ITEM 7.0

CONSIDERATION OF OPTIONS WHICH MAY INCREASE THE NORTHERN SETBACK OF THE TOP LEVEL OF THE BUILDING.

CURRENT STAIR CIRCULATION

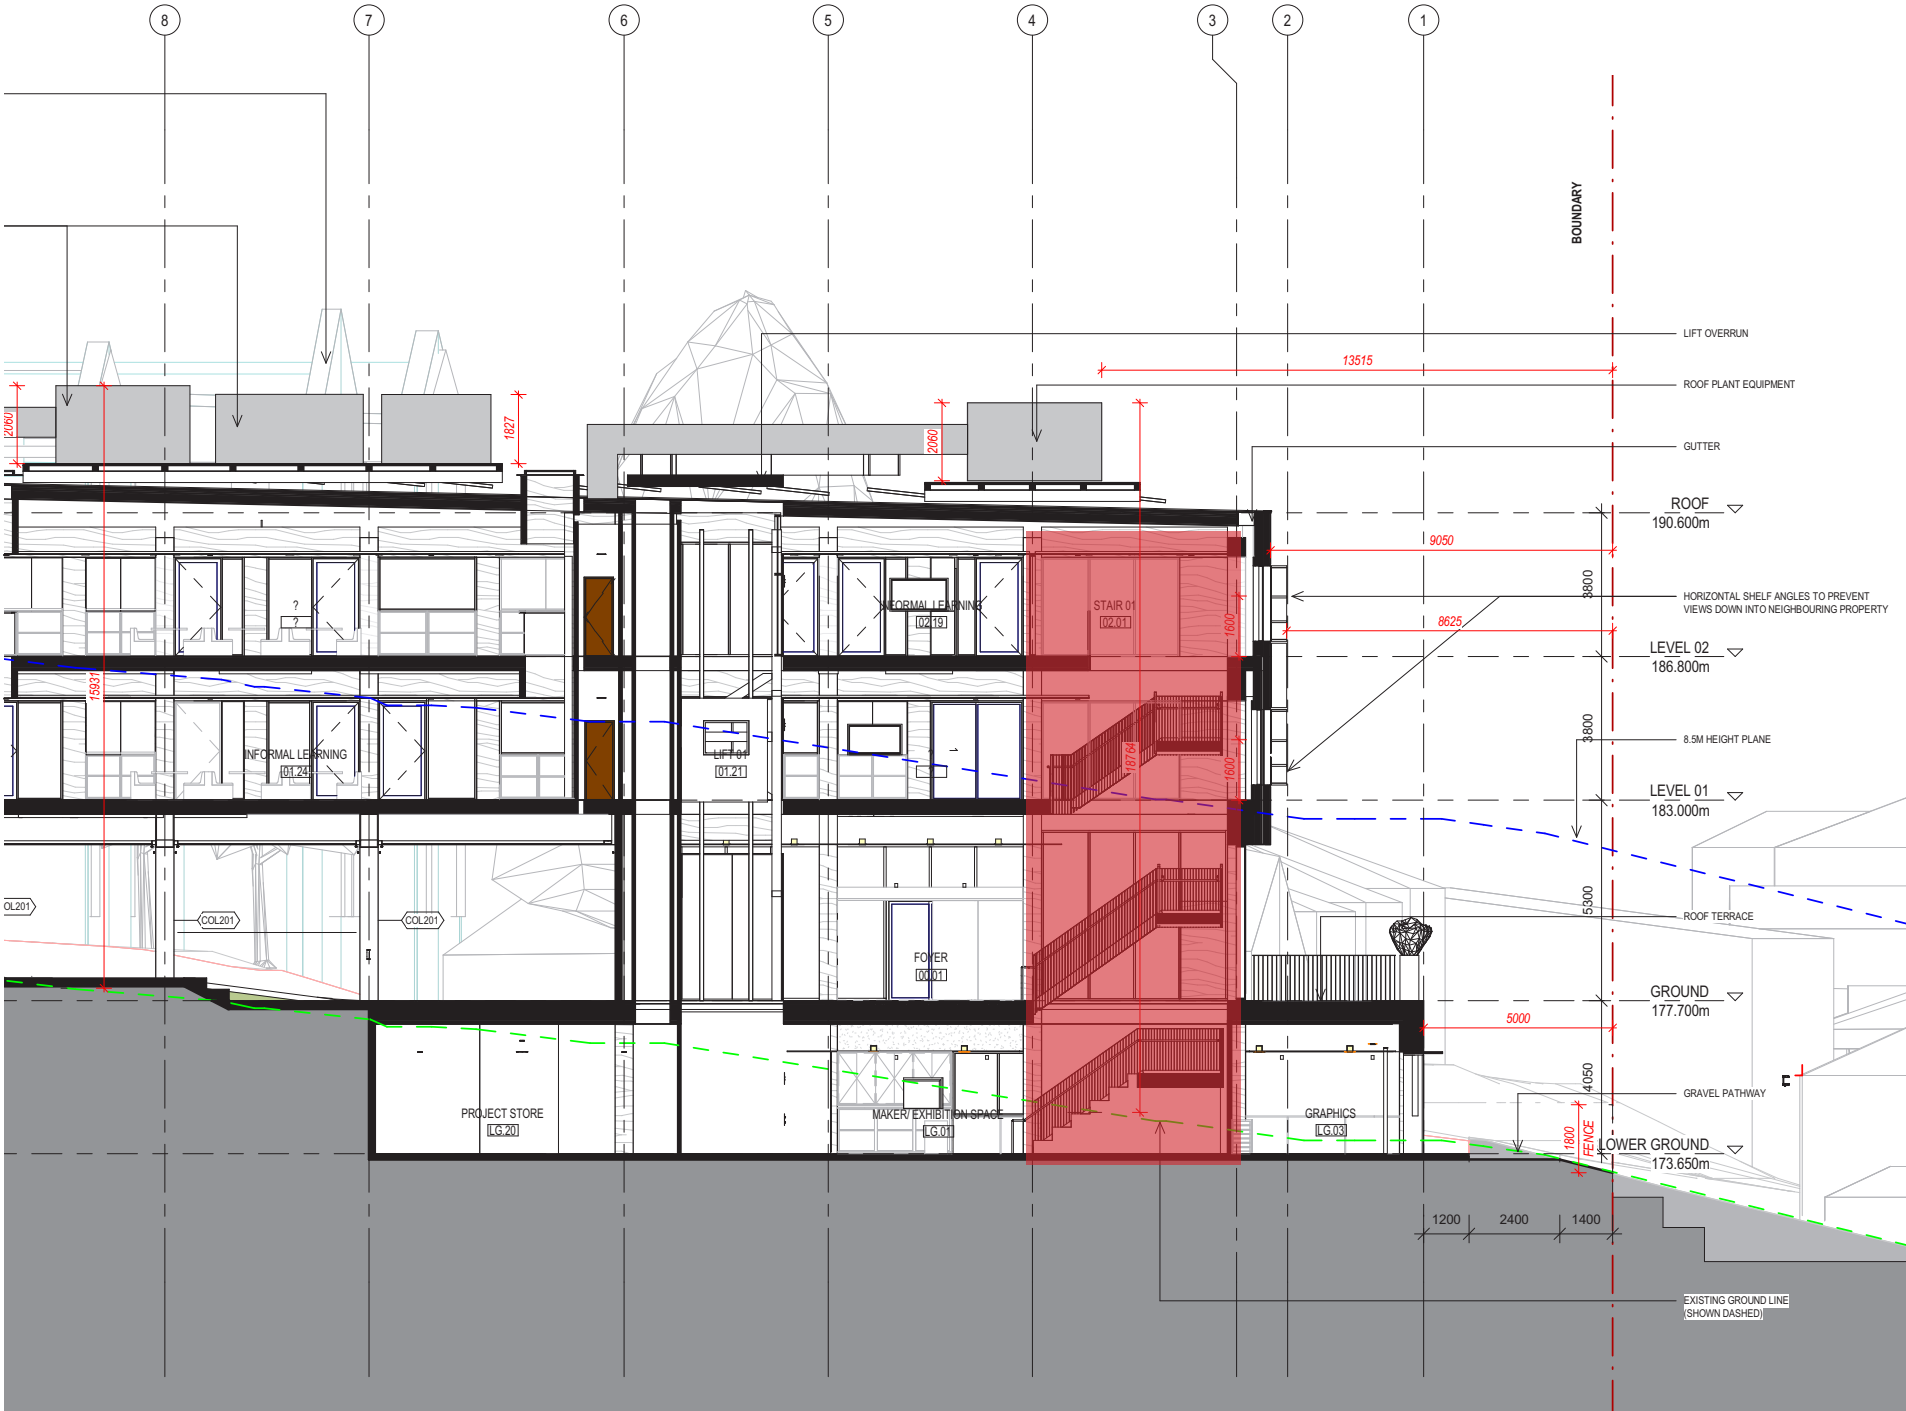
- WHILST MAINTAINING THE CEREMONIAL WALKWAY, TO INCREASE THE SETBACK OF THE UPPER LEVELS WOULD REQUIRED A CHANGE IN THE INTERNAL CIRCULATION OF THE BUILDING
- CURRENTLY THE STAIR SERVICES LOWER GROUND TO LEVEL 2 EFFICIENTLY.

CURRENT STAIR CIRCULATION WITH SETBACK TO UPPER LEVELS

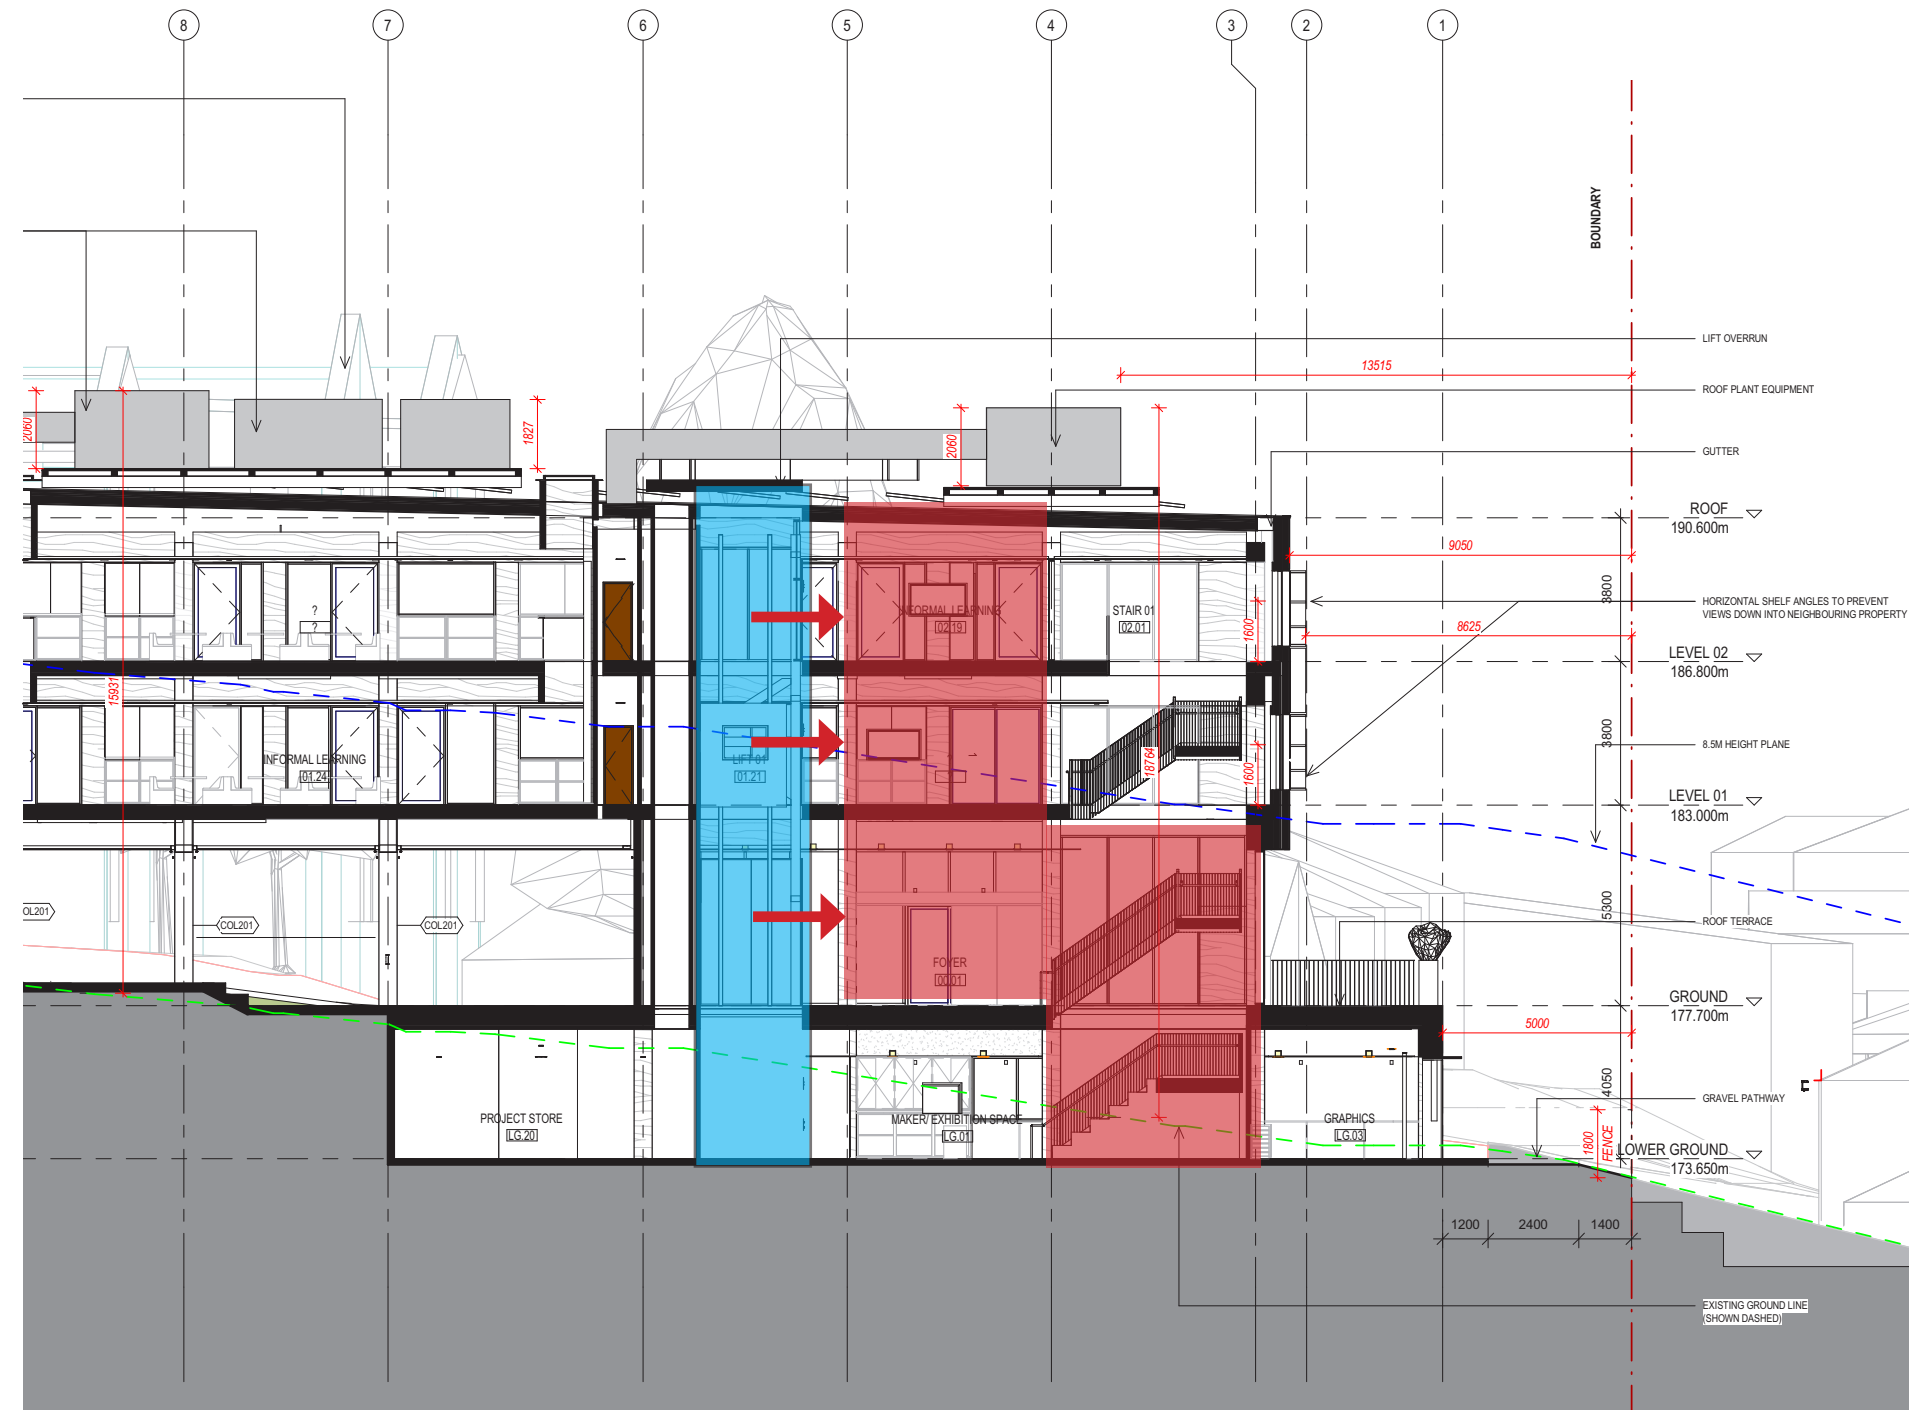
- STAIR SHIFTED TO INCREASE SETBACK FROM NORTHERN BOUNDARY - MOVED 1 STRUCTURAL BAY
- CHANGING STAIR LOCATION WILL RESULT IN INEFFICIENT FLOOR CIRCULATION AND CLASH WITH INTERNAL LIFT ENTRY.
- LIFT CORE WILL NEED TO BE RELOCATED
- RESULT IN THE LOSS OF 2 INFORMAL LEARNING SPACES & ENTRY LOBBY
- BUILDING ENVELOPE AND FLOOR AREA WILL INCREASE DUE TO RELOCATION OF LIFT AND TEACHING SPACES
